**ADDENDUM NUMBER FOUR
HOLMBERG BRIDGE PANEL REPLACEMENT
CONTRACT NO. R-14-012**

CITY OF CHATTANOOGA, TENNESSEE

Figure 8

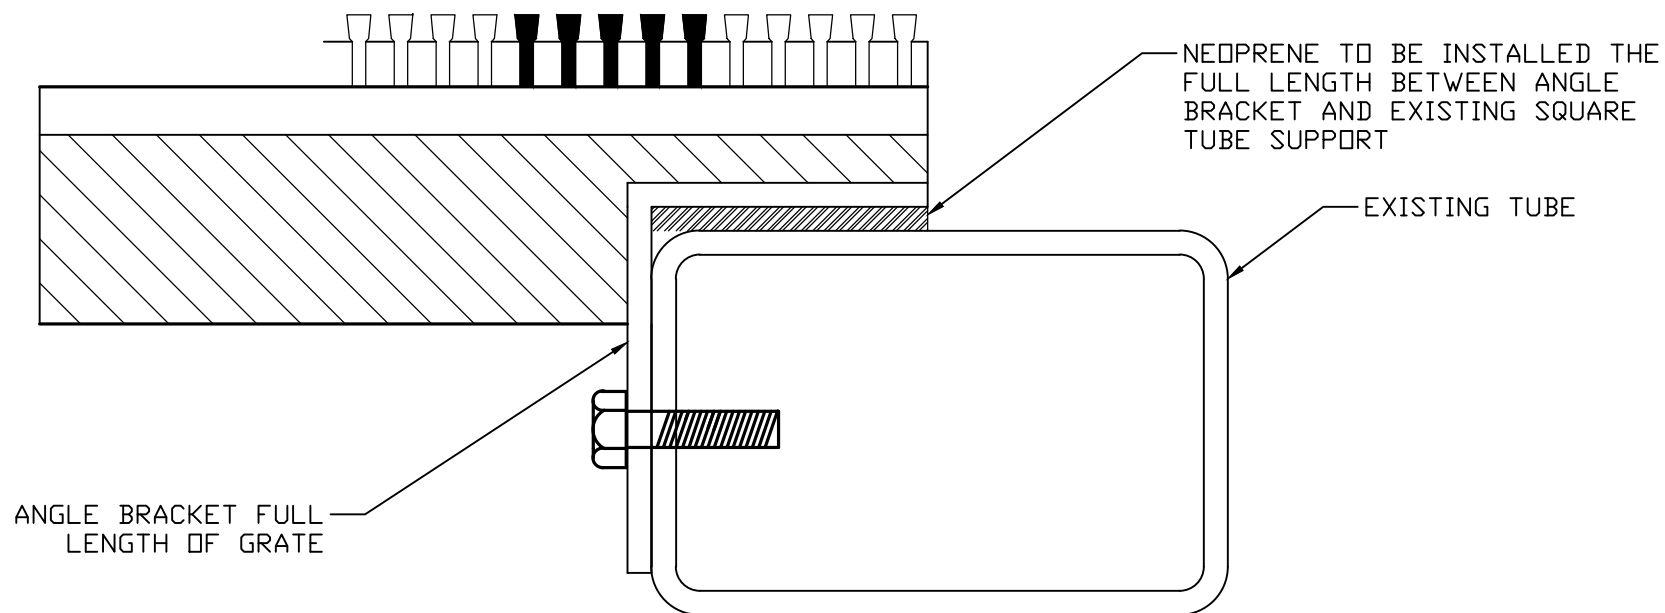
Figure 8 have been revised to show the placement of the metal angle and neoprene that the panels should rest on. Addendum 3 incorrectly identified this as Figure 6.
